Item No. 7.1.2
Design Review Committee
August 14, 2014

TO: Chair and Members of Design Review Committee
Original Signed
SUBMITTED BY: Brad Anguish
Brad Anguish, Director, Community and Recreation Services
DATE: July 29, 2014
SUBJECT: **Case 19390: Substantive Site Plan Approval – 5690 Spring Garden Road, Halifax**

EXISTING & PROPOSED ELEVATIONS

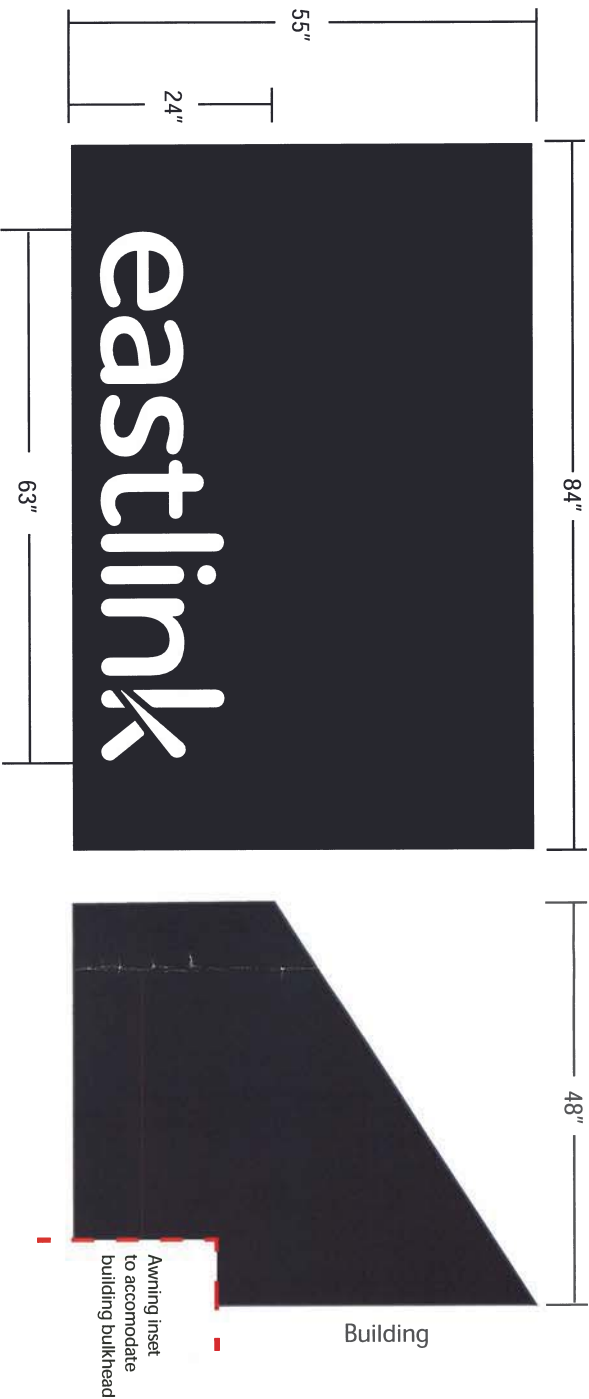
The Design Manual requires awnings over the sidewalks of pedestrian-oriented streets, as a means of providing weather protection. This proposal incorporates an awning at the retail store entrance on Spring Garden Road. Staff recommended that the applicant install an awning to cover the sidewalk for the length of the building; however, an awning that will be limited to being over the Spring Garden Road entrance is a suitable improvement and is proportional to the limited extent of the alterations to the building. The encroachment license for the proposed awning is subject to approval by a separate approval process.

The Design Manual encourages frequent entries along pedestrian-oriented street frontages. When renovations were undertaken to the Eastlink store, a door was removed from the South Park Street elevation. As there continue to be additional entrances along the South Park Street elevation as well as large storefront windows, the removal of a single door does not have a substantial impact.

The Design Manual prohibits mechanical or utility functions (such as trash vestibules) along pedestrian frontages. There is an existing wooden fence enclosure for residential solid waste on side of the building fronting South Park Street. In staff's opinion, it is acceptable for the storage area to remain in its current location as this is an existing situation and as there is sufficient screening from the street.

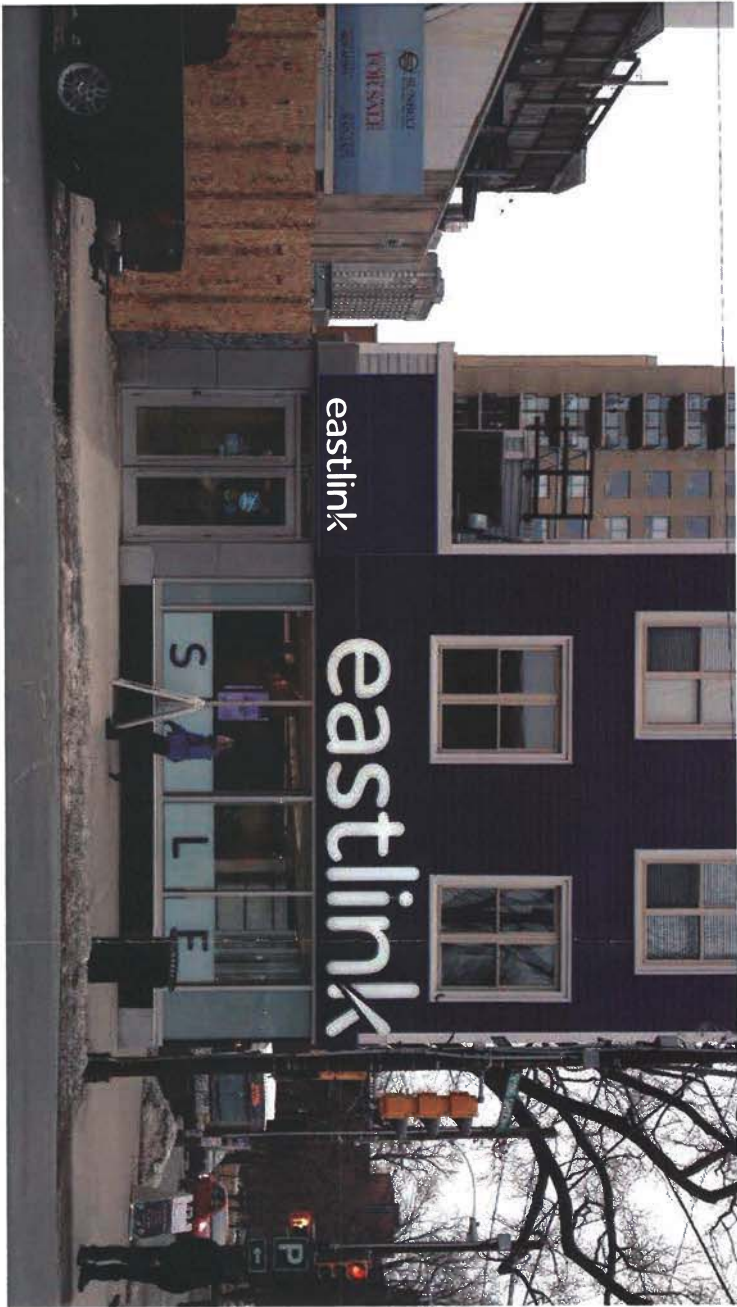
Eastlink acknowledges that much of this work, as noted above, is now complete. In addition to this completed work, Eastlink requests permission to add a new Awning Sign, to provide weather protection on a pedestrian-oriented street, and to reinforce the location of the public entrance. This is as per section 2.3.c of the Design Manual.
